**Economic and Social Council**Distr.: General  
20 February 2020

**World Forum for Harmonization of Vehicle Regulations****Working Party on Passive Safety****Sixty-seventh session**

**Regulation No. 134 (Hydrogen and Fuel Cell Vehicles)****Proposal for the 01 series of amendments to  
Regulation No. 134 (Hydrogen and Fuel Cell Vehicles  
(HFCV))****Submitted by the expert from the Netherlands \***

Model B

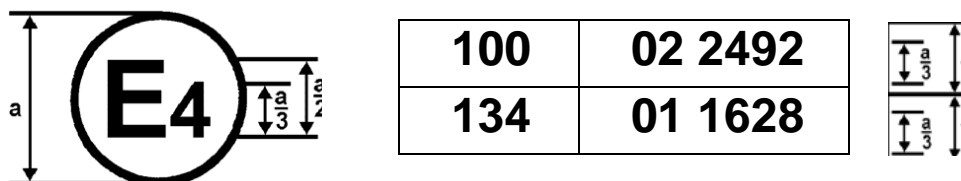
The above approval mark affixed to a vehicle shows that the road vehicle concerned has been approved in the Netherlands (E 4) pursuant to Regulations Nos. 134 and 100.\* The approval number indicates that, at the dates when the respective approvals were granted, Regulation No. 100 was amended by the 02 series of amendments and Regulation No. 134 was ~~still in its original form.~~ **amended by the 01 series of amendments."**
